## **PINOLE PLANNING COMMISSION MEETING AGENDA**

**August 10, 2026**

PINOLE SHORES PHASE 2

**Figure 1: Project Location**

**A4.1**

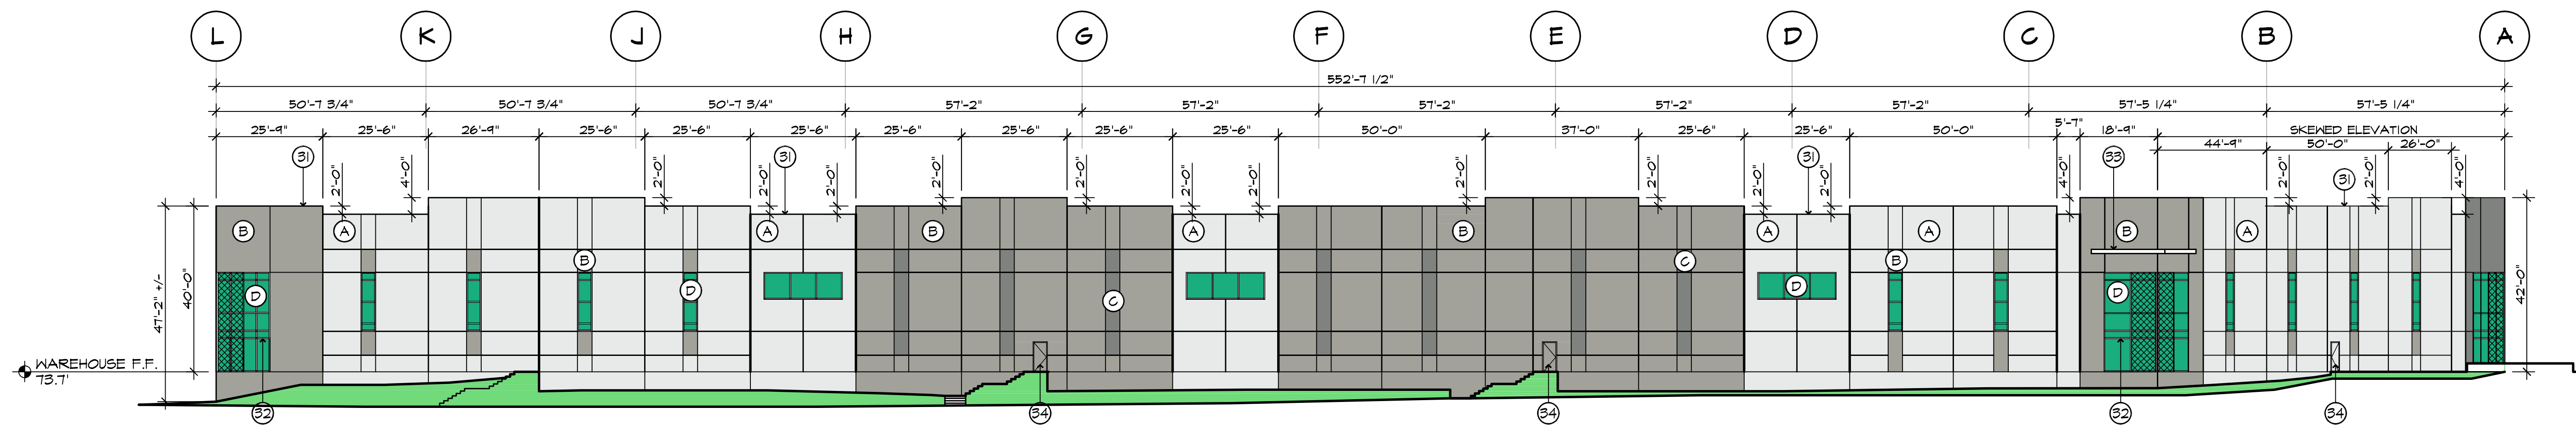
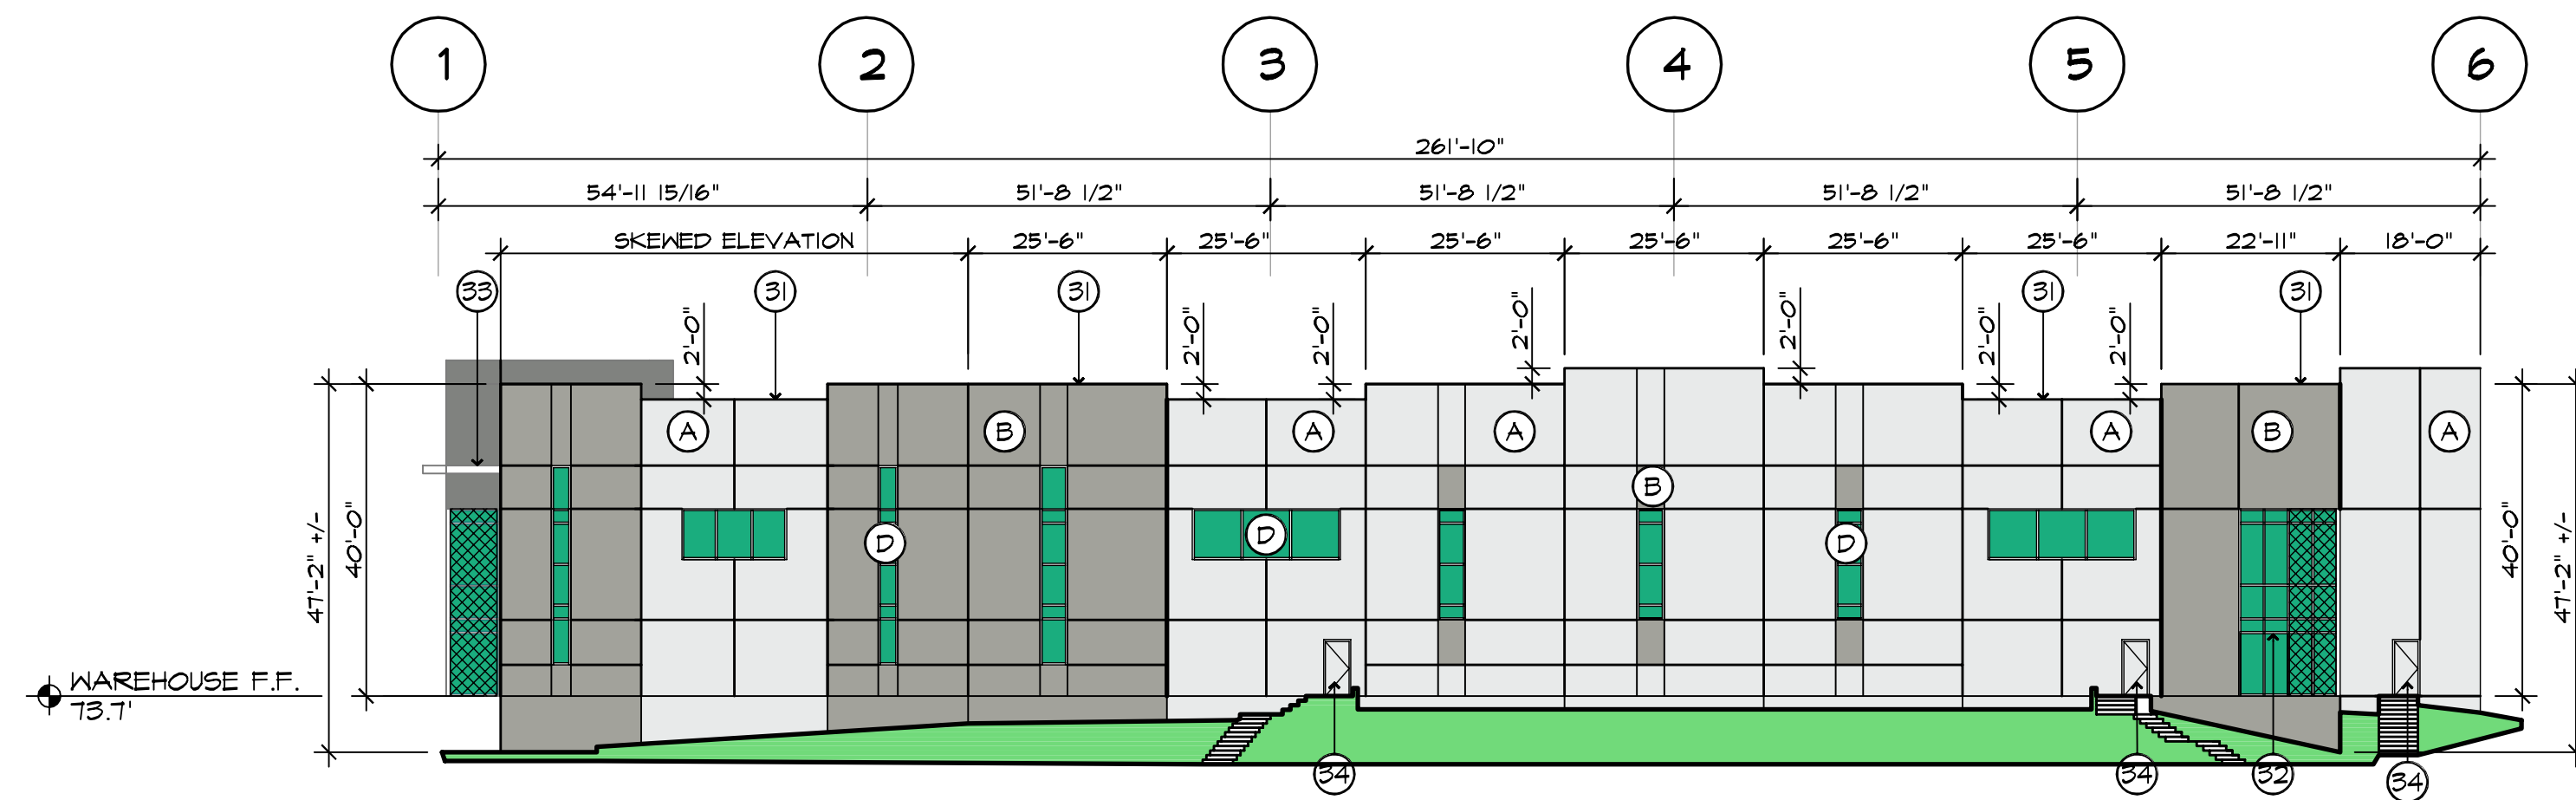
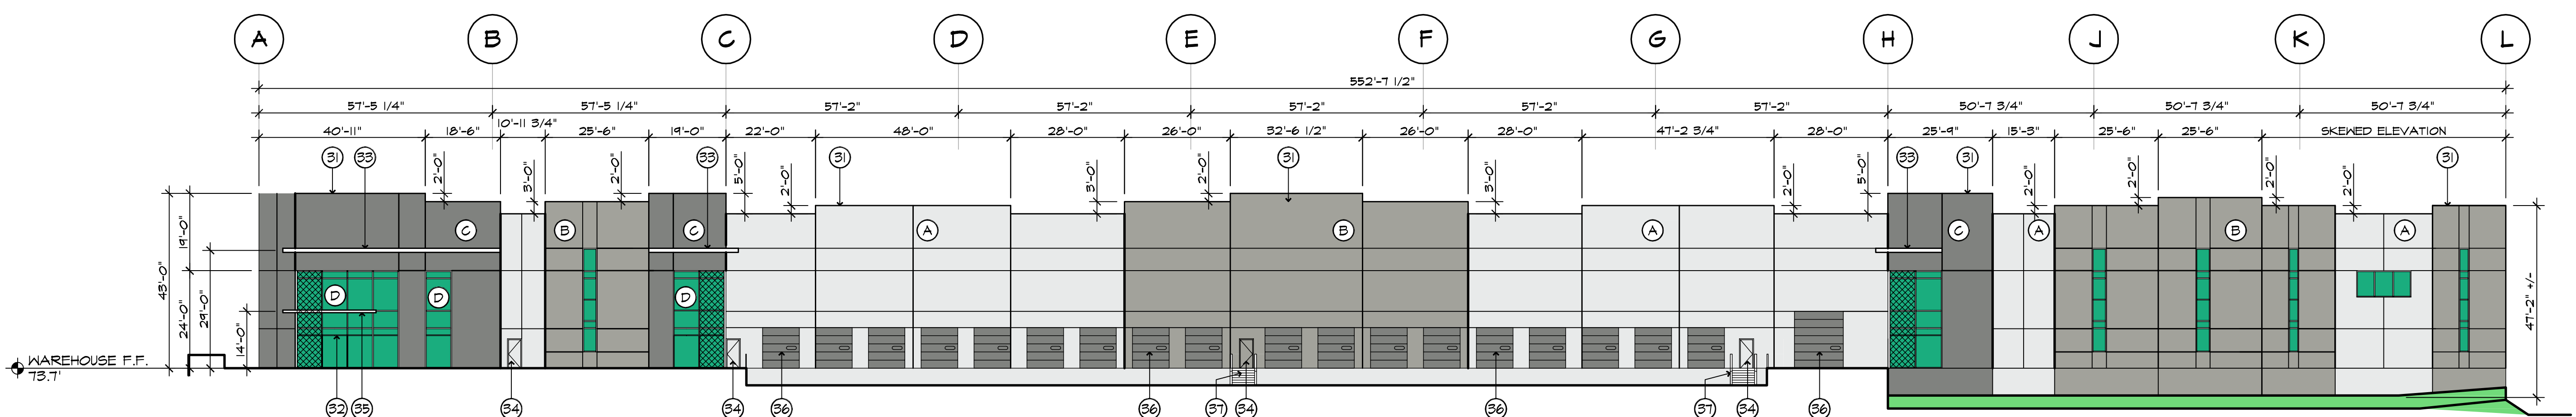
CD-5: Pager A4.1 - Should show the following:

2. The elevation does not show the differentiation of the parapet similar to the drawing on page A3.2.

4. The only features that are shown on A4.1 and A4.2 has to do with the buildings. There is no articulation or rendering that measures the difference of the undulation of the buildings. There are no other architectural features shown on the plans (e.g., stamped concrete on the roads and/or sidewalks)

*Colors E and F have been removed from the color legend for clarify. Additional information has been added to the elevation keynote legend on A4.1 which better describes the materials and colors of the different elevation elements. The color legend is designed to designate the large colored areas which show up as colored in the elevations for A4.1 (mainly the paint colors rather than finishes of smaller elevation elements)*

*Labels have been added to the elevation dimensions on sheet A4.1 that identify which elevation runs are skewed.*

**A6.1**

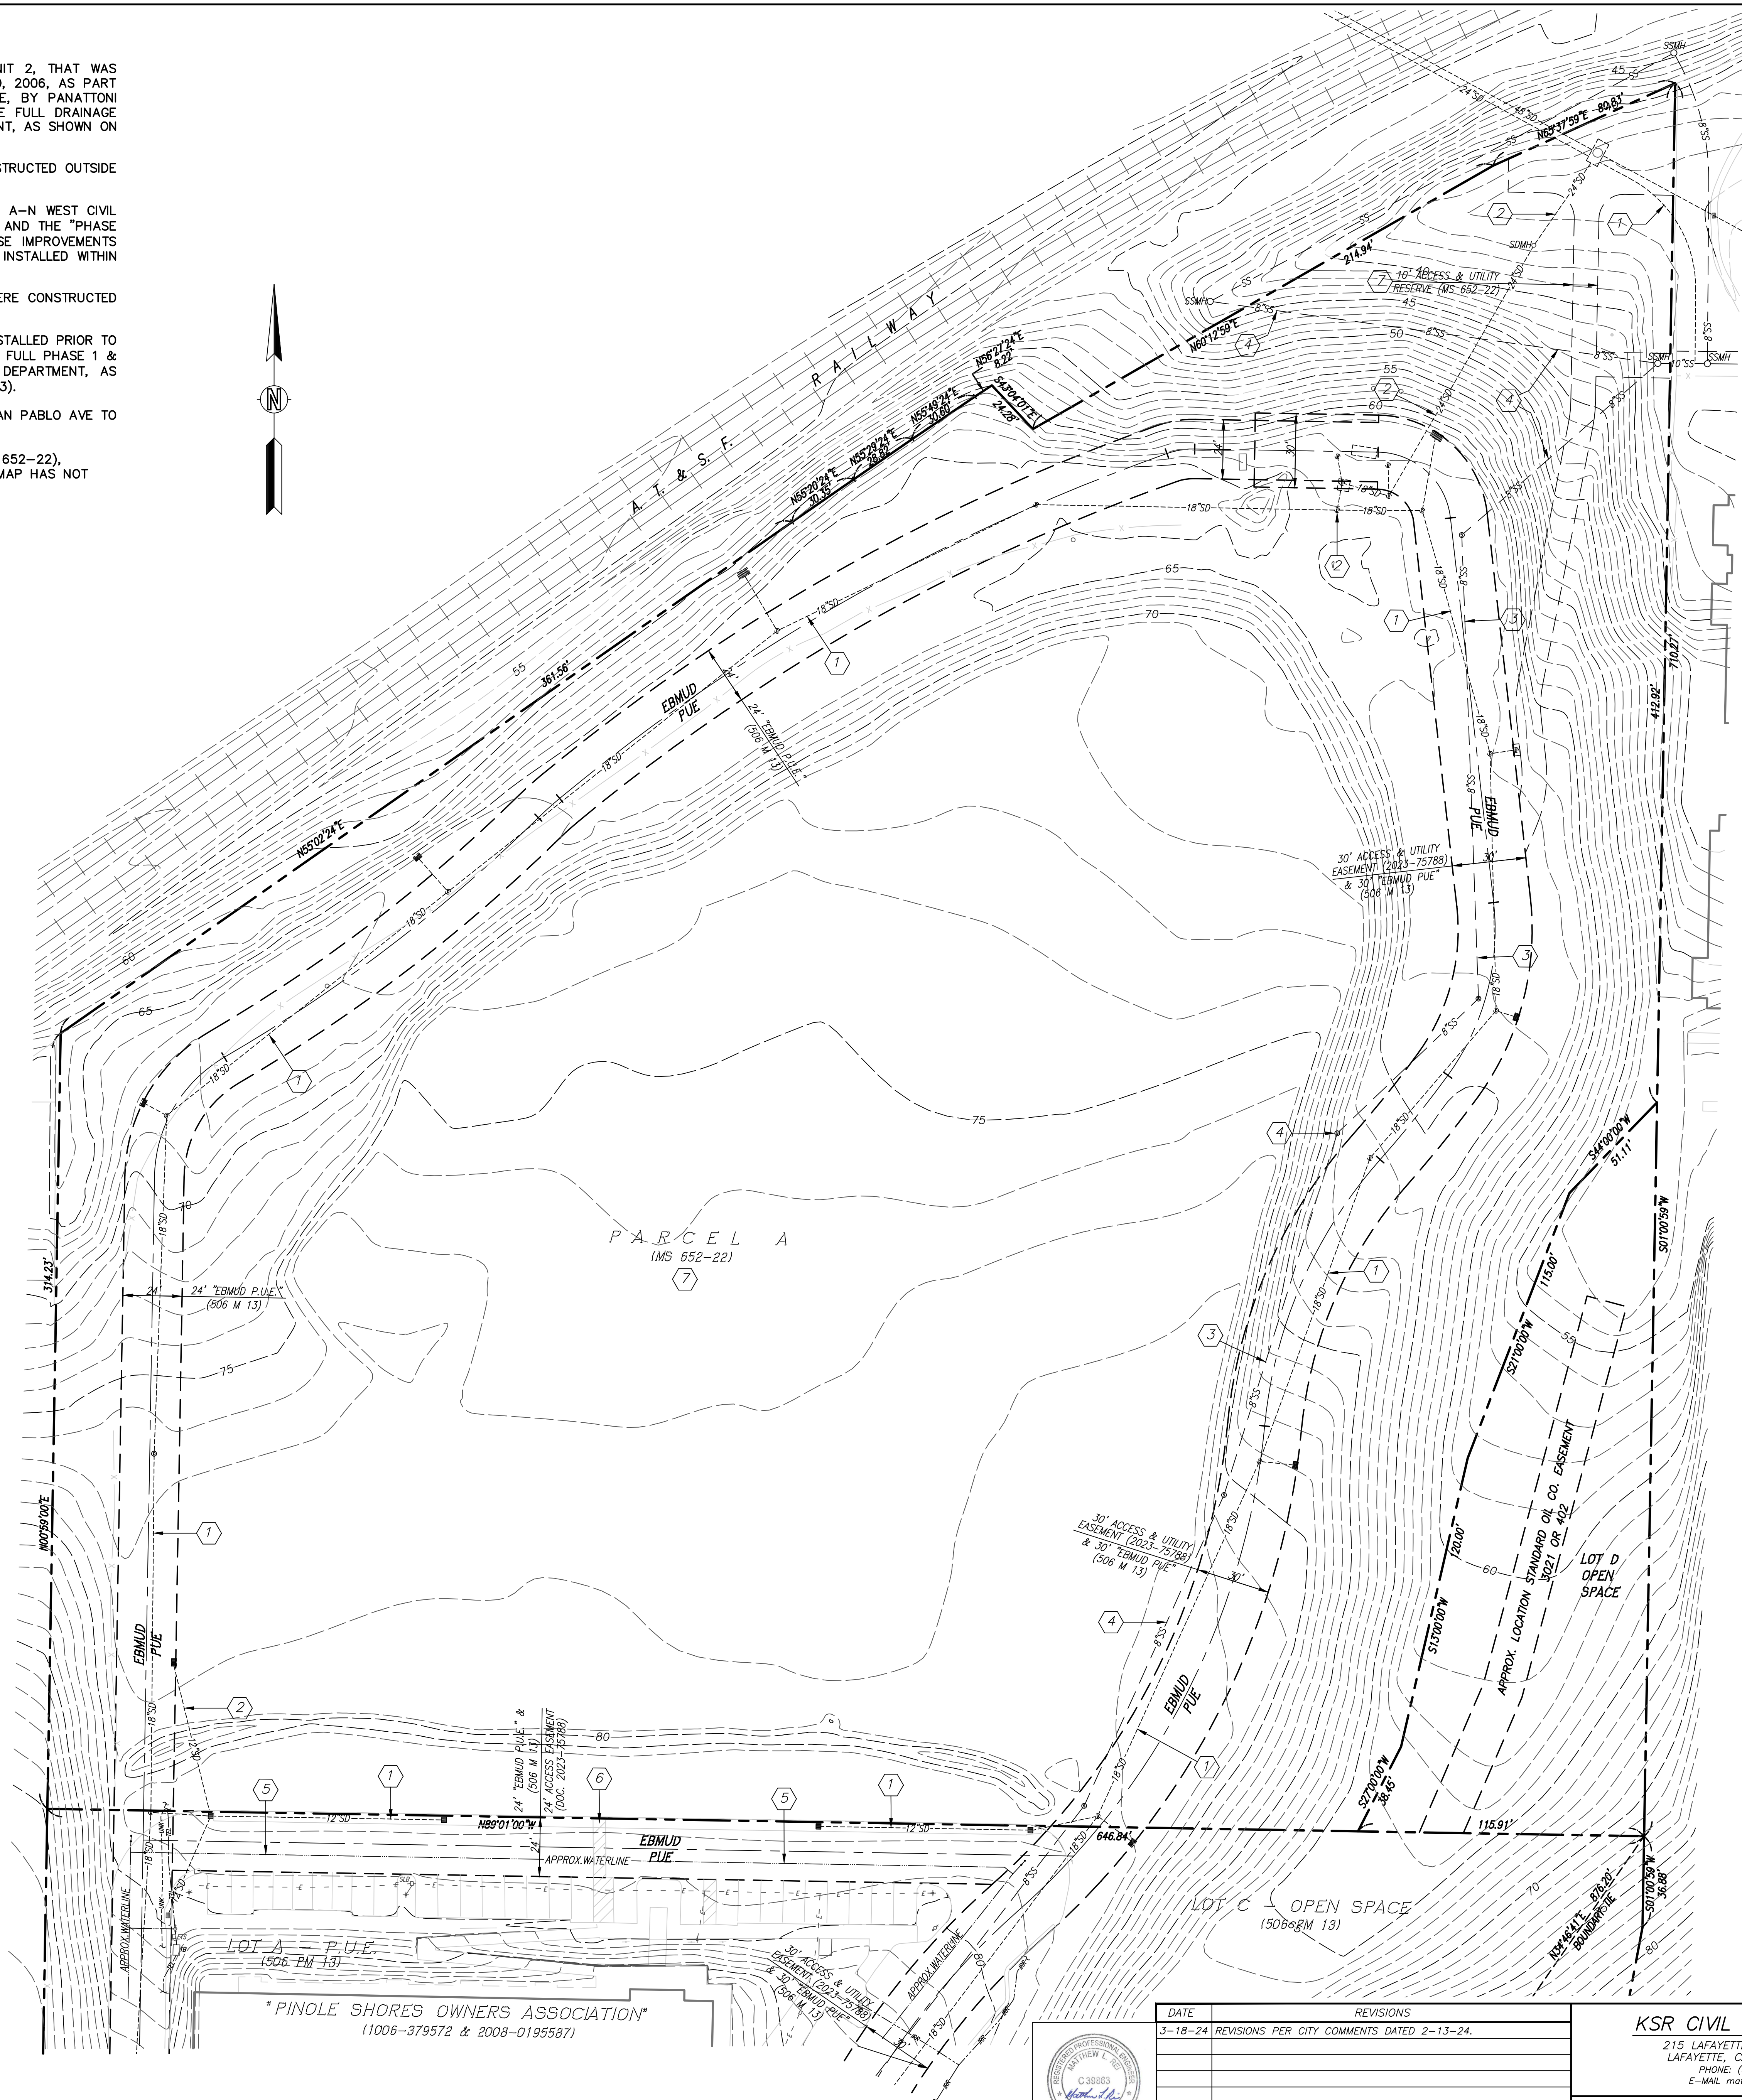
CD-8 Page A6.1 - Should show the following:

*Site plans and view arrows have been adjusted for better accuracy and clarity to correspond with the rendered views. An improved aerial rendered top down 2D site plan that shows the building and surrounding landscape plan has also been updated on sheet A5.1, new sheet A5.2 and sheet A6.1.*
